FACPAC Contract Change Order

Tier 1 Project: CHHS Phase 2

11-2

**AIA**[®]**Document G709™ – 2018****Proposal Request**

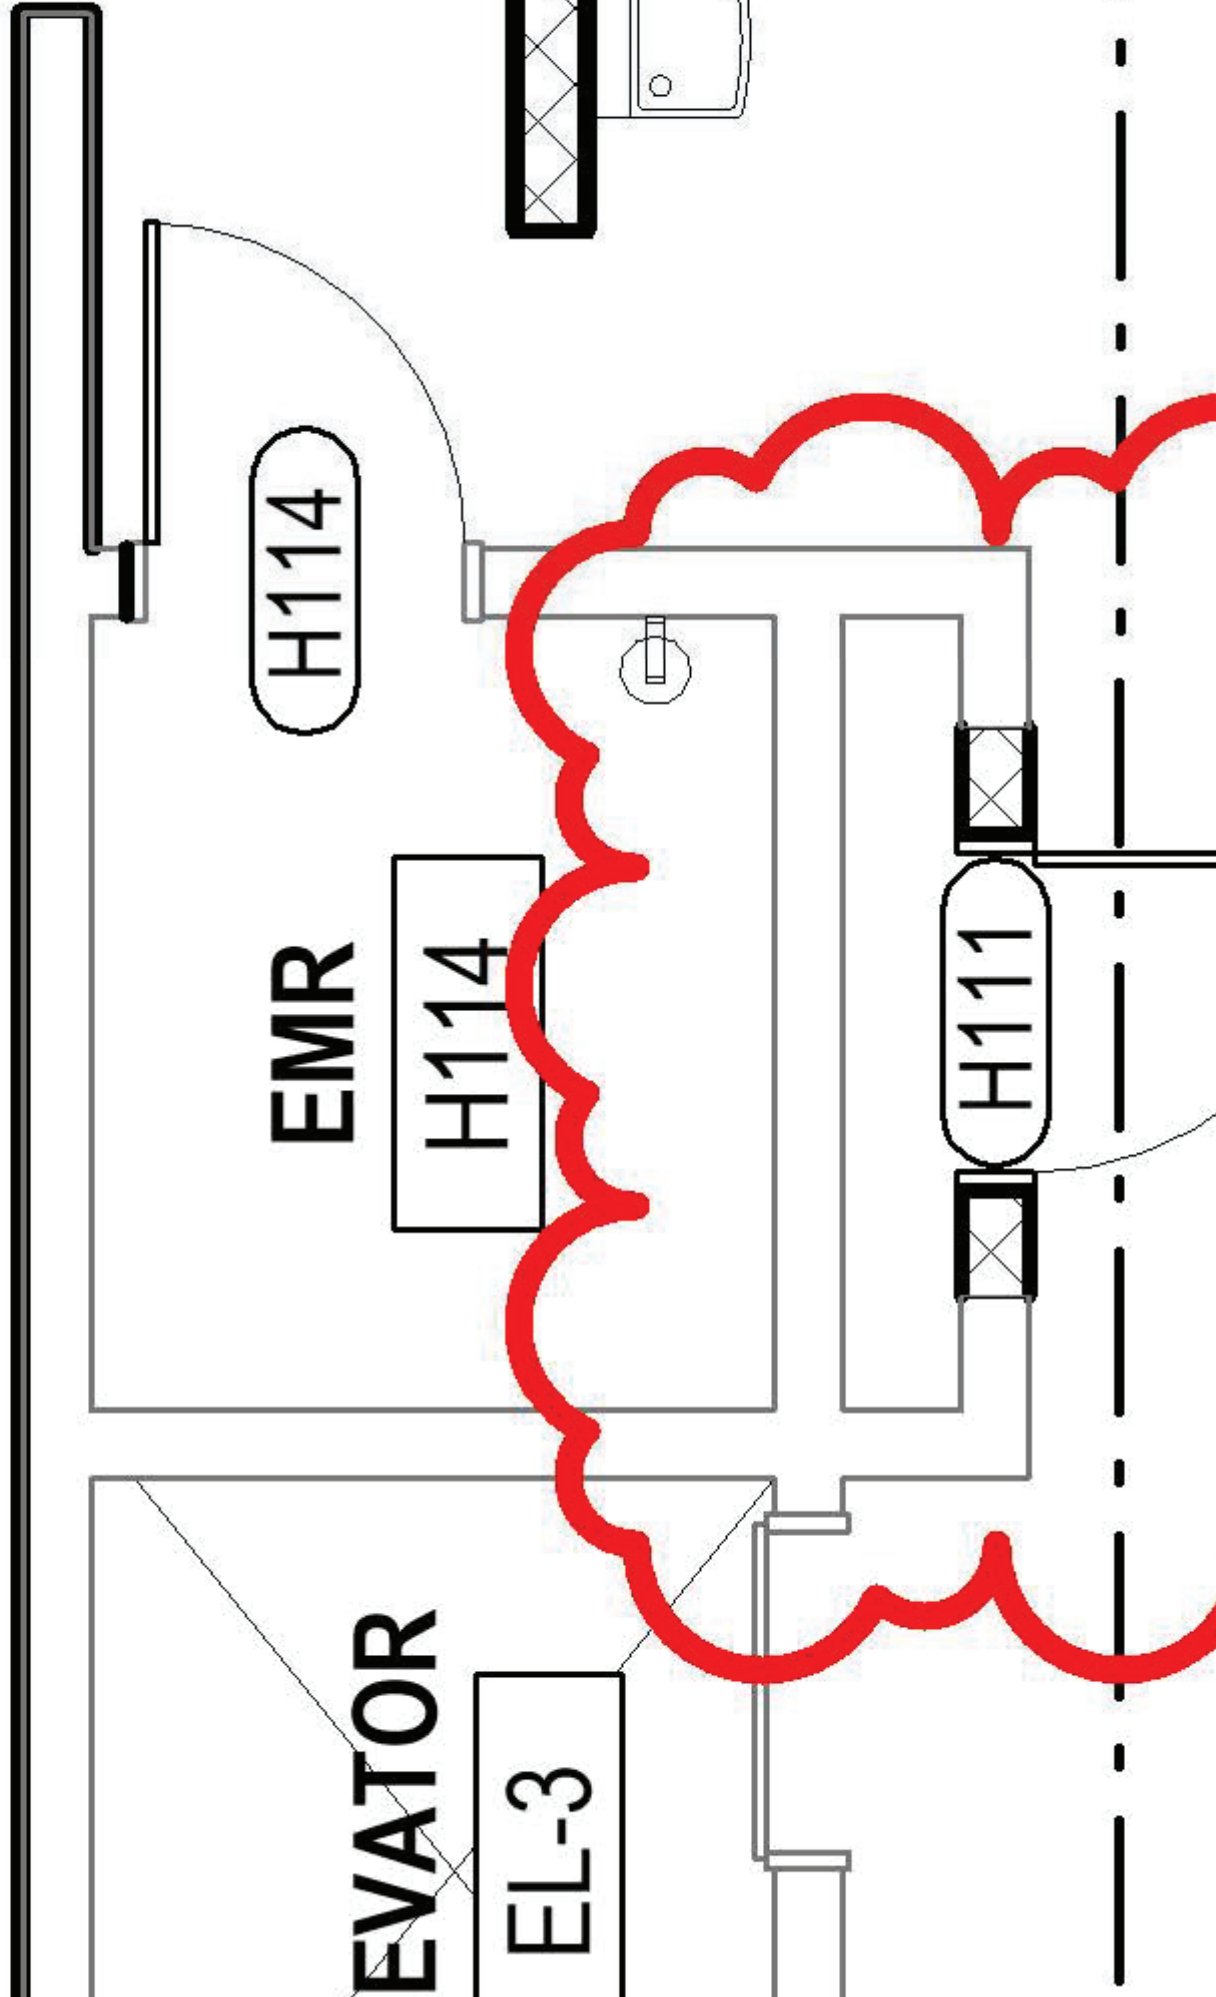
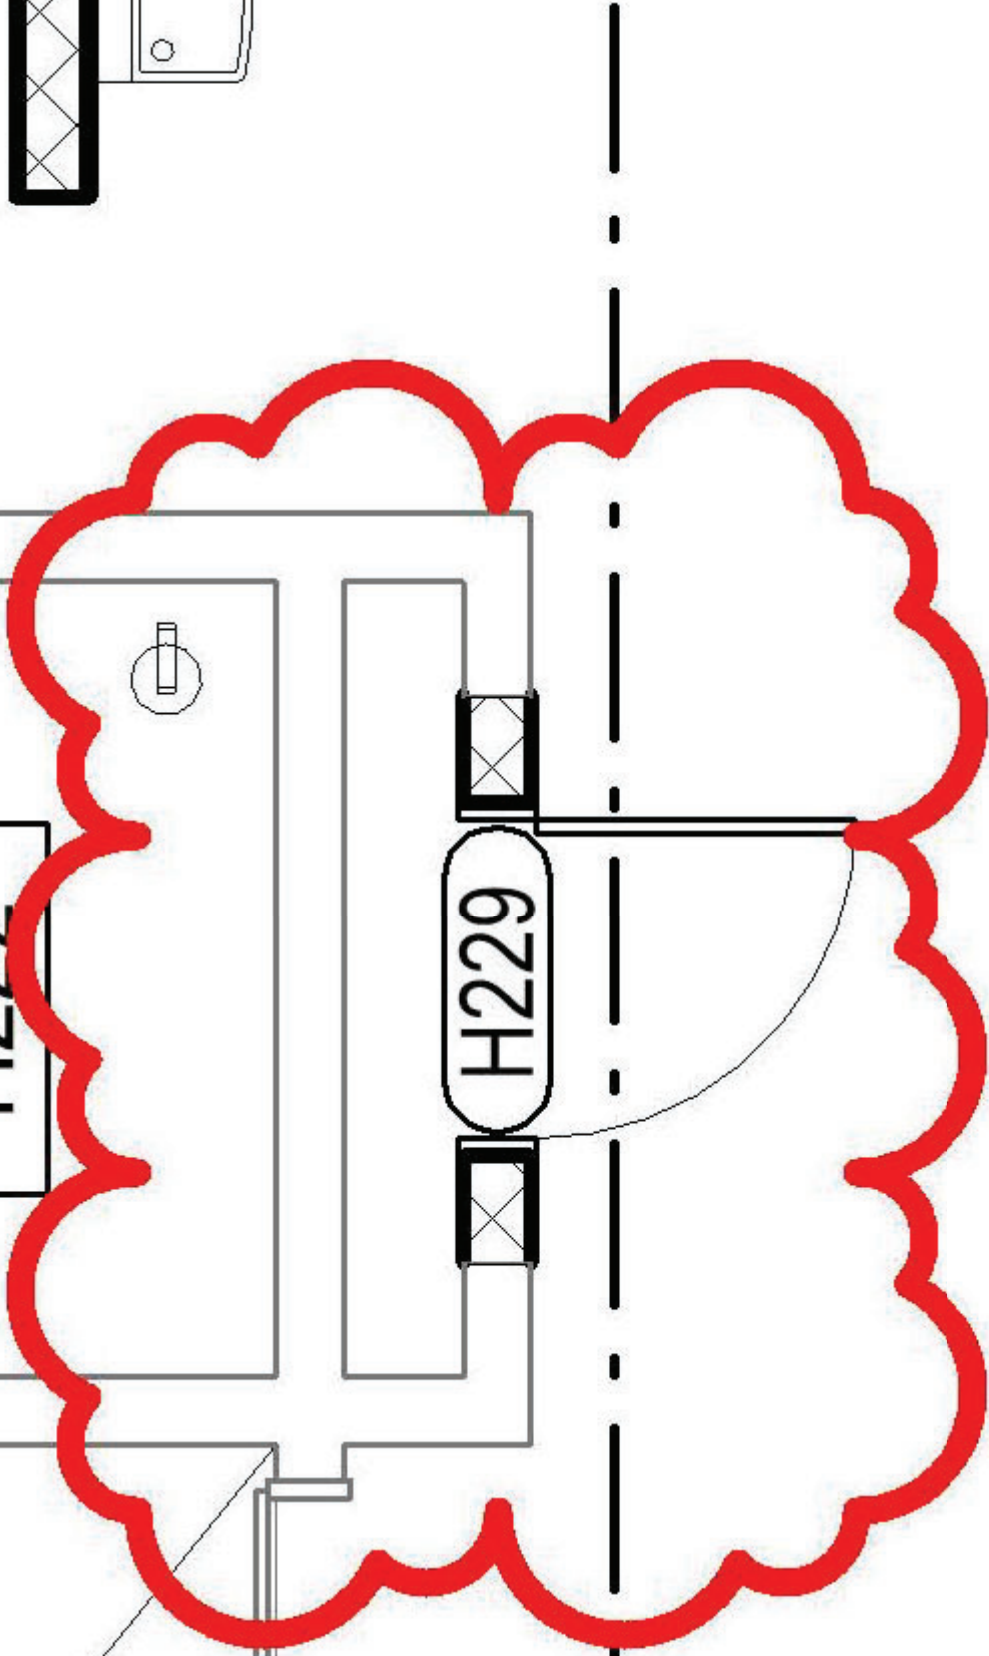
The owner would like to remove 2 display cases and turn them into closets.

Provide pricing for demolition of the sliding window, CMU below and bottom of display case. Provide a 3'-0" by 7'-2" single "Type F" wood door with hollow metal frame.

Match door hardware on H215A door. Infill with CMU as required.

Match adjacent finishes and paint interior of room P-1, add B-1 rubber base, RT-1 rubber flooring and add light fixture.

This PR will require us to paint walls, paint door frames, and caulk door frames to the walls on both sides. See below for price break down.
